State Plumbing Board

PLUMBING RULES AND REGULATIONS

3 CCR 720-1

1301.5 Typical graywater system for toilet and urinal flushing

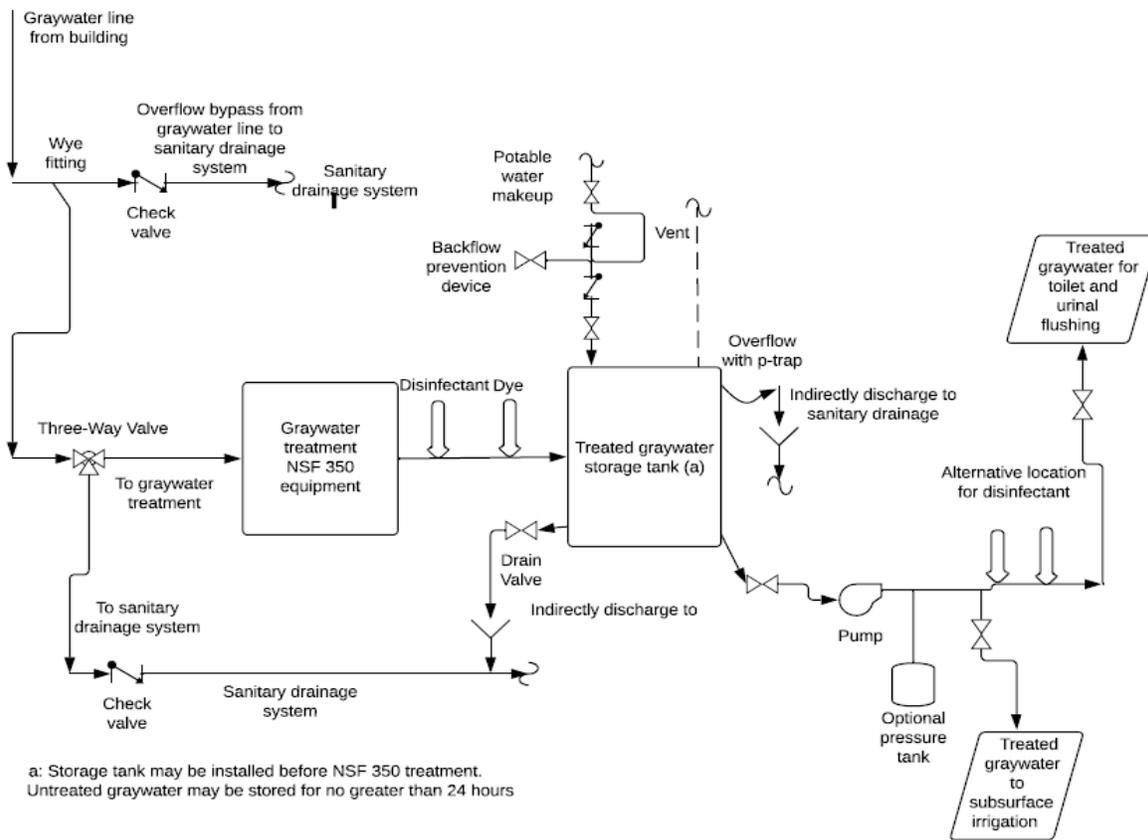
v[YJ15]. IPC Section 1301 General

Add new figure 1301.5

1301.6 Typical graywater system for disbursed subsurface irrigation system

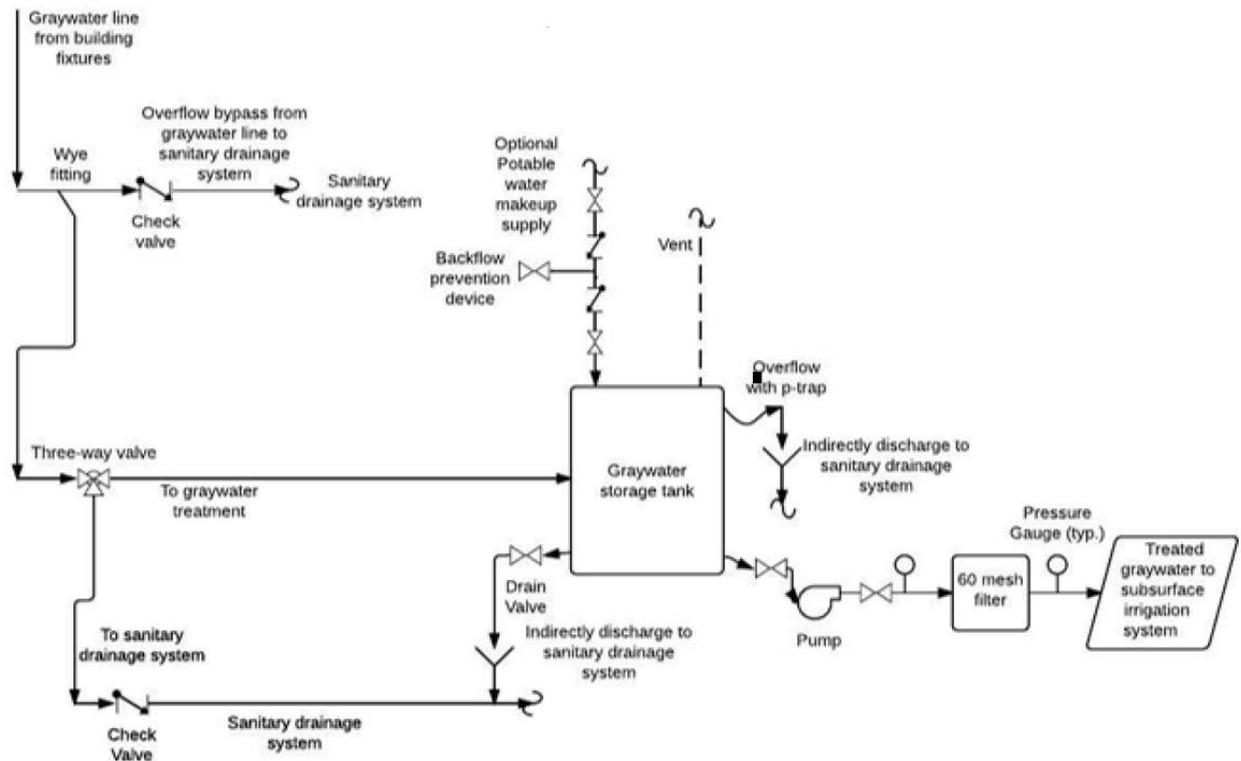
Add new figure 1301.6

1301.7 Typical graywater system for mulch basin subsurface irrigation

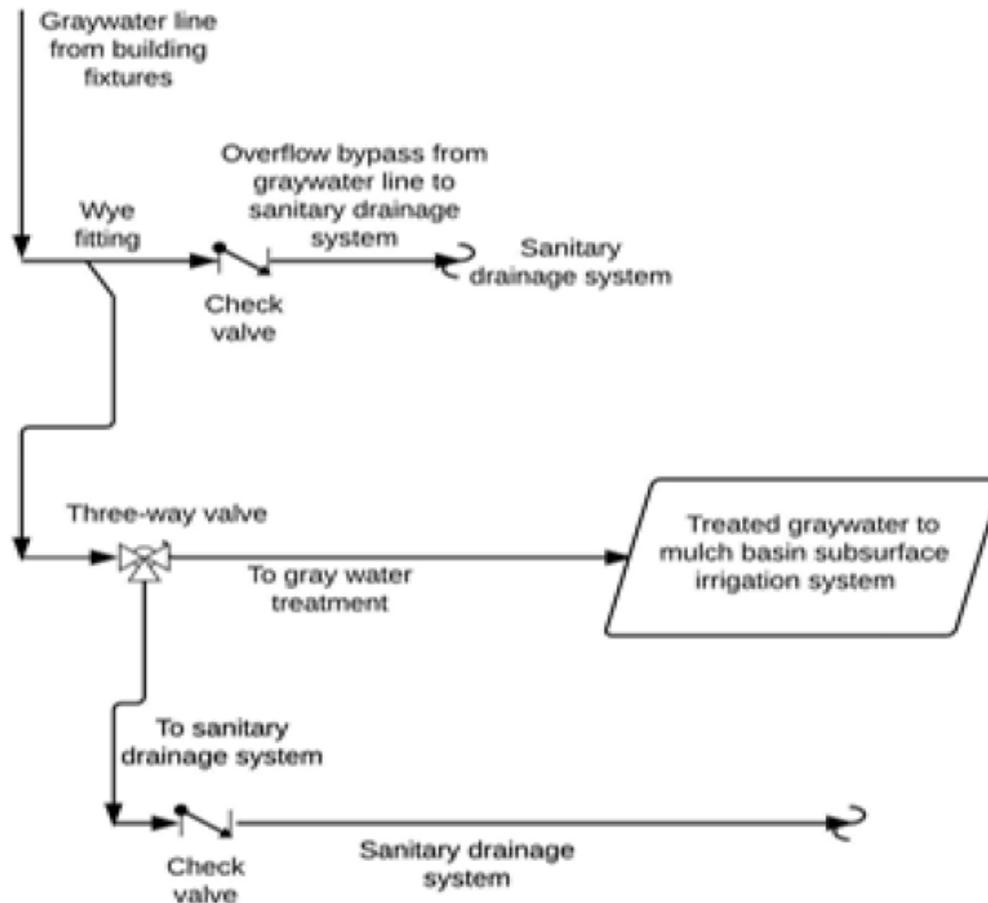
Add new figure 1301.7

2910.6 Typical graywater system for disburSED subsurface irrigation system

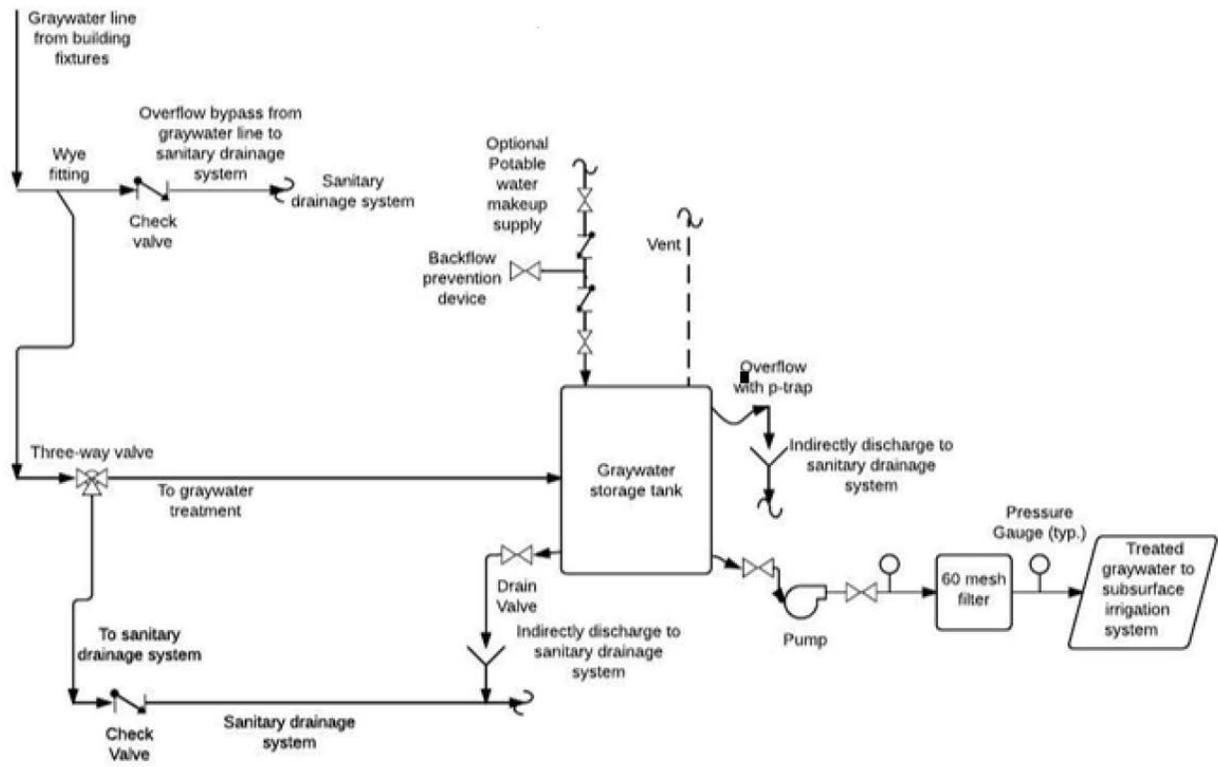
hh|YJ28|. IRC Section P2910 Graywater recycling systems

Add New Figure Section 2910.6

2910.7 Typical graywater system for mulch basin subsurface irrigation

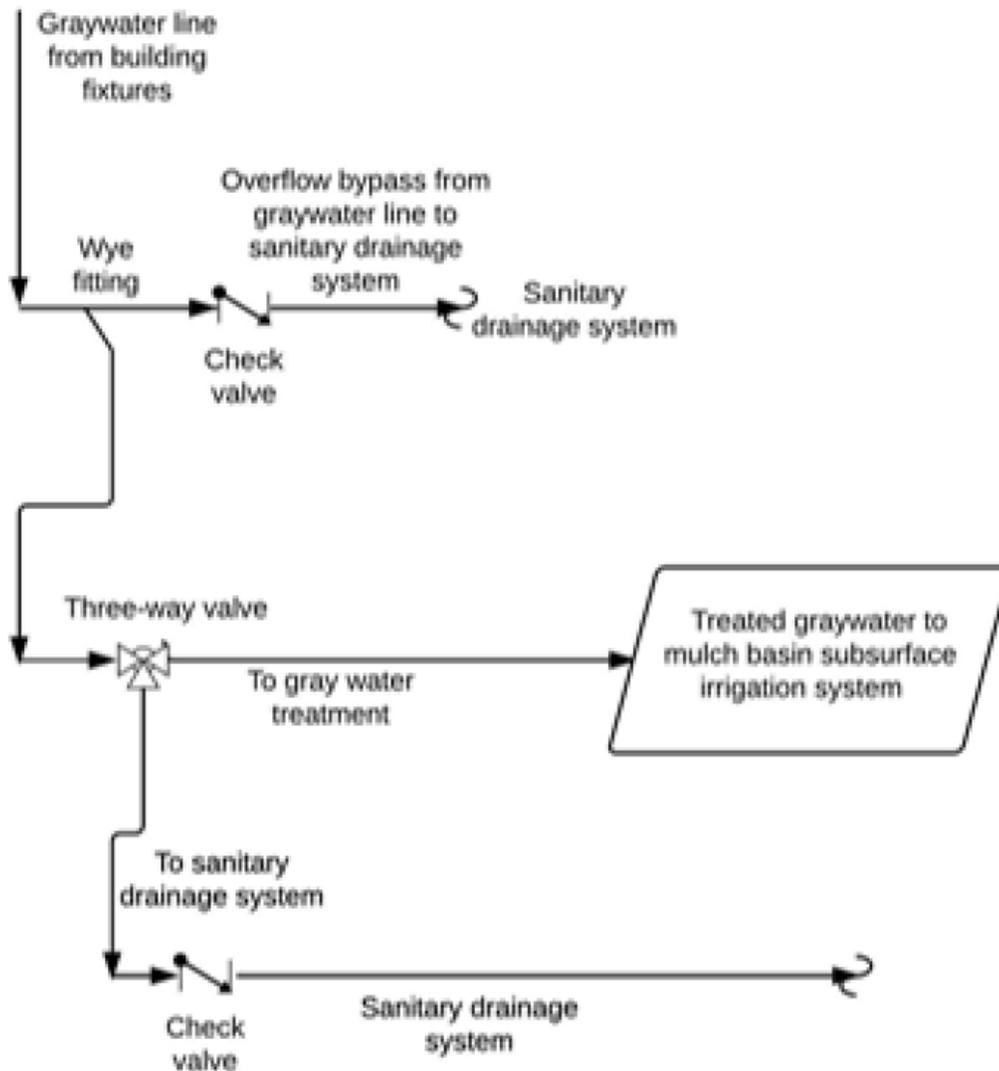
ii. IRC Section P2910 General

Add new figure Section 2910.7
